## 1968 Corvette: Service Bulletin: Refrigerant Leak

Subject: Refrigerant Leak
Model and Year: 1968 Vehicles with Air Conditioning
Source: Chevrolet Dealer Service Technical Bulletin
Bulletin No: 68-T-56
Section: Ia
Date: July 12, 1968

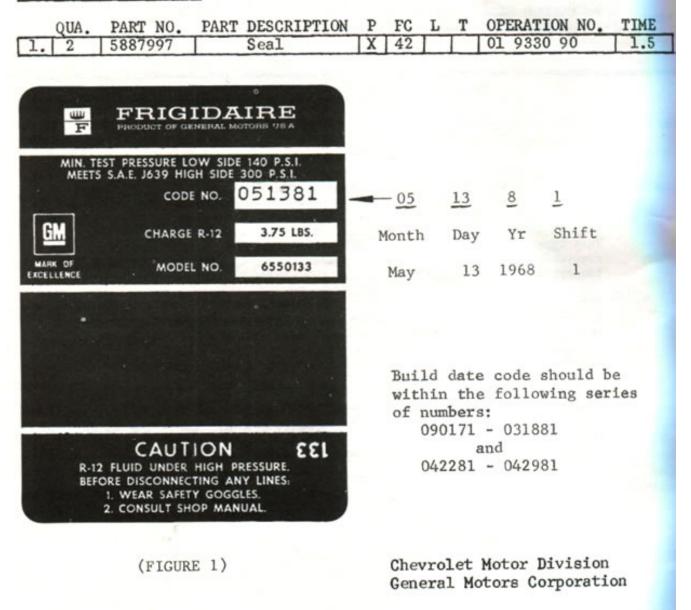
In production, the suspected seals were used between September 1, 1967 and March 18, 1968 and again between April 22, 1968 and April 29, 1968. Compressors built within these dates may be identified by noting the date stamped on the identification tag (See Fig. 1) located on top of the compressor.

4. Add a dab of white paint after the shift digit on identification tag.
